No. 0042-031, Rev. II  
ATA Code 53-40  
Recurring Inspection

**SUBJECT:** FUSELAGE - INSPECTION OF FORWARD WING ATTACH POINT

**SYNOPSIS OF CHANGE:** Service Instructions rewritten in current format. Deleted requirement to remove the attach bolt for inspection. MATERIAL and ACCOMPLISHMENT INSTRUCTIONS revised to use improved current configuration parts. Closed serial effectivity of these Service Instructions to exclude those airplanes which were manufactured with improved parts. Option is given to retrofit affected airplanes with improved parts.

Figure 1.

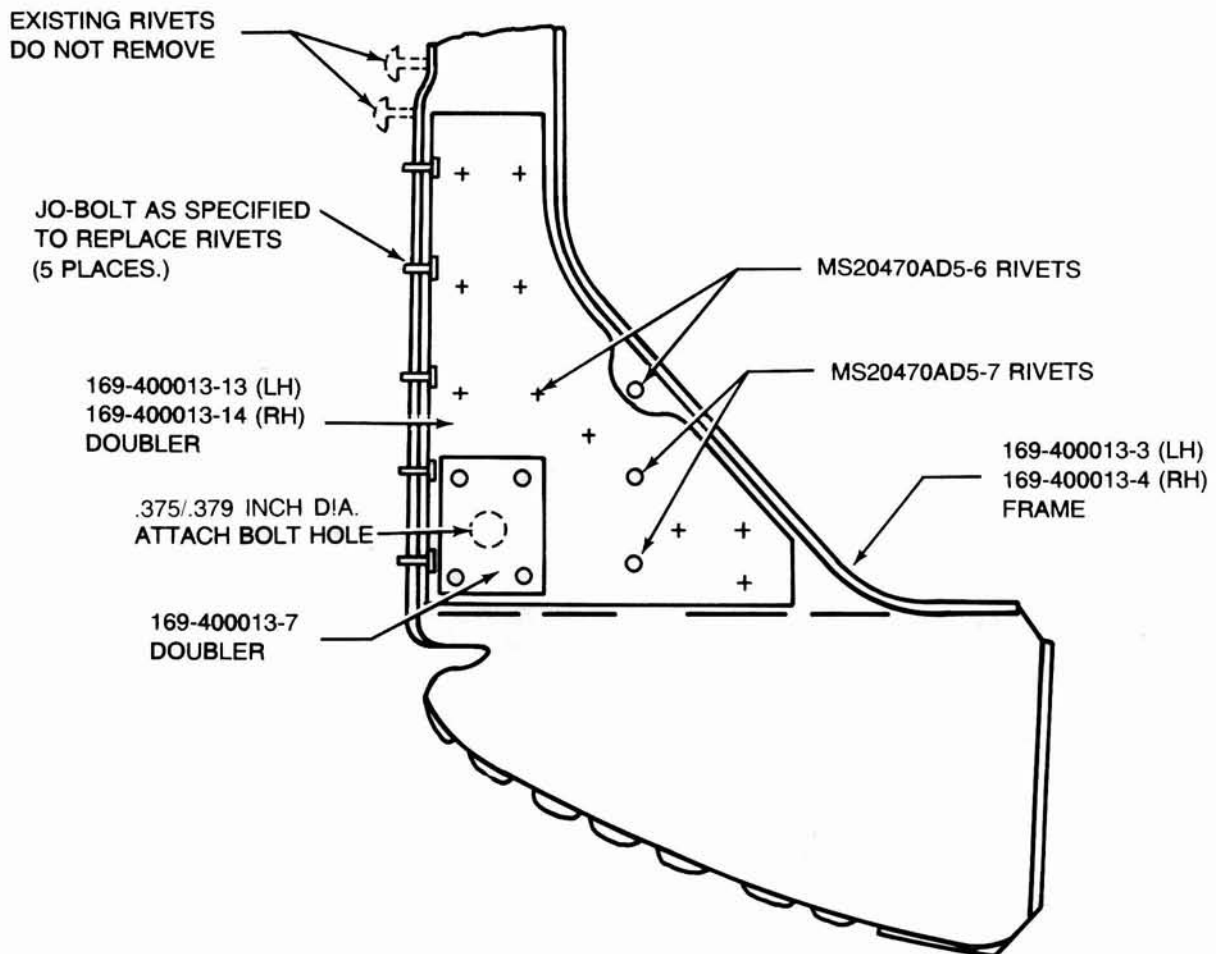
3. Drill out the three rivets through the bracket and frame, and the five rivets through the outboard flange of the bracket and the fuselage skin (See Figures 1 and 2), and discard the bracket.

Figure 3.

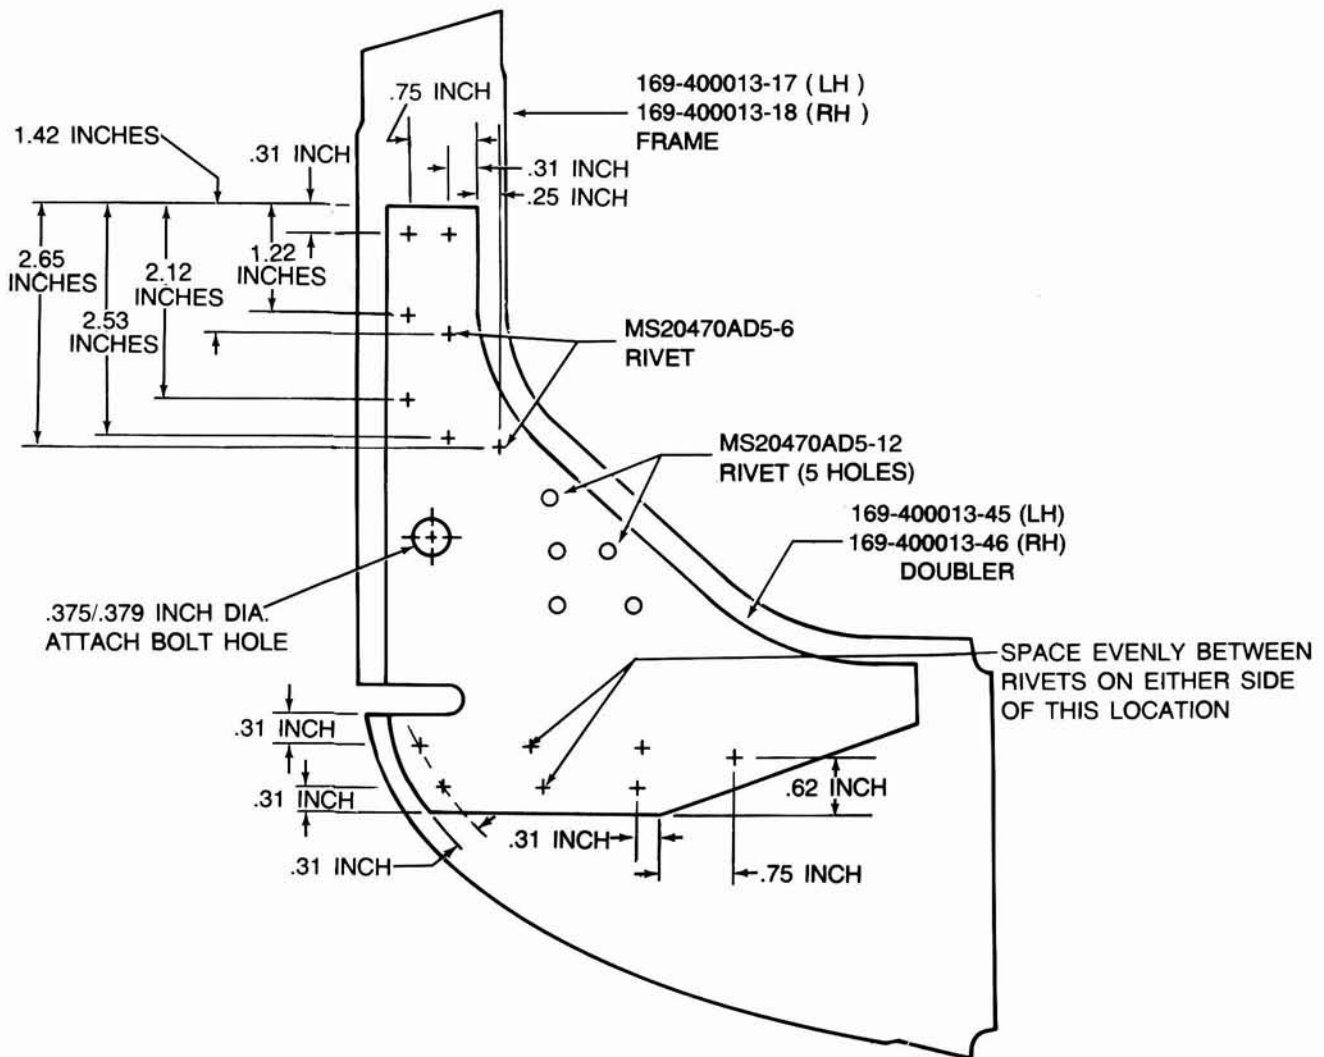
- b. Remove the nut on the wing attach bolt and measure the gap between the wing attach frame and the bracket to ensure the gap is  $.320 \pm .010$  inch. Do not remove the attach bolt.

- c. If the gap is of the proper size, ensure that a P/N AN960-616 washer is installed under the head of the bolt, install a P/N 100951DD063YN aluminum washer, then a P/N AN960-616 washer and install an MS20365-624A nut on the attach bolt and torque the nut to 100/120 inch-pounds.

- d. If the gap exceeds  $.320 \pm .010$  inch, back the wing attach bolt out just far enough to install P/N AN960-616 and/or AN960-616L washers as required to fill any gap between the lug on the wing and the bracket or frame. If a P/N AN960-616 washer is not installed under the head of the bolt, the bolt must be removed.

- e. Ensure a P/N AN960-616 washer is installed under the head of the wing attach bolt and install the bolt. Install a P/N 100951DD063YN washer on the bolt next to the bracket, then a P/N AN960-616 washer, and install an MS20365-624A nut. Torque the nut to 100/120 inch-pounds and reinstall the side panels, carpets and seats.

Figure 4.

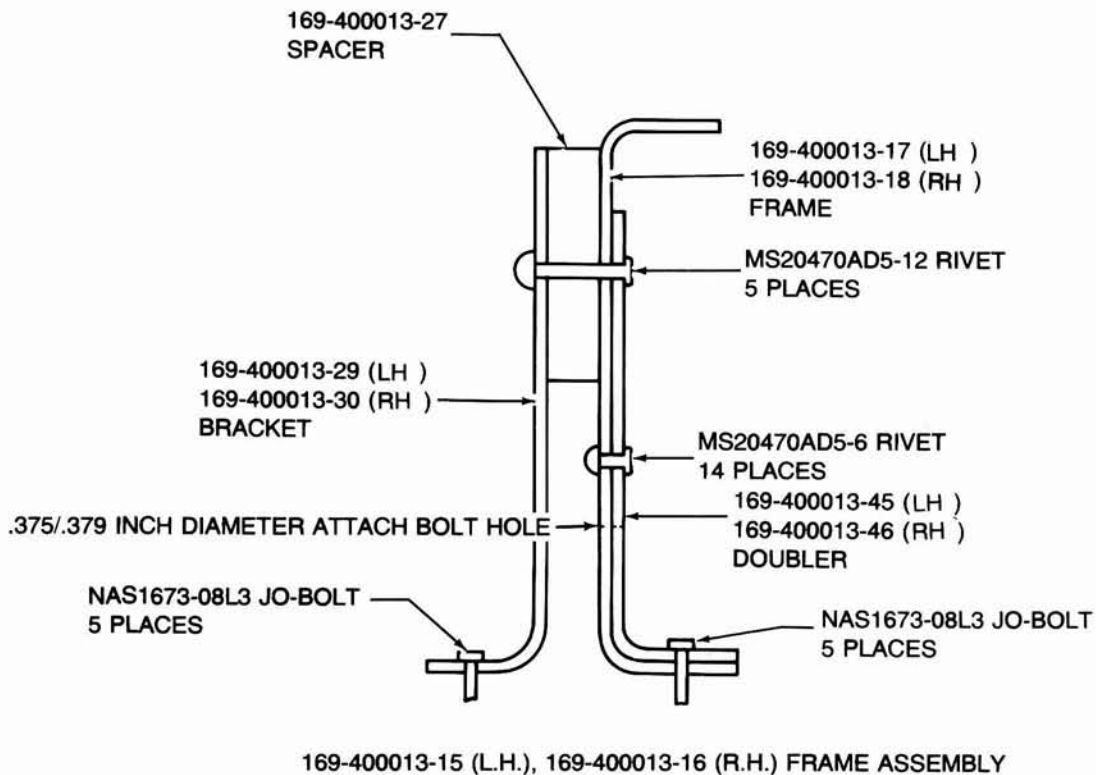
5. Position a P/N 169-400013-45 (LH) or P/N 169-400013-46 (RH) doubler on the frame
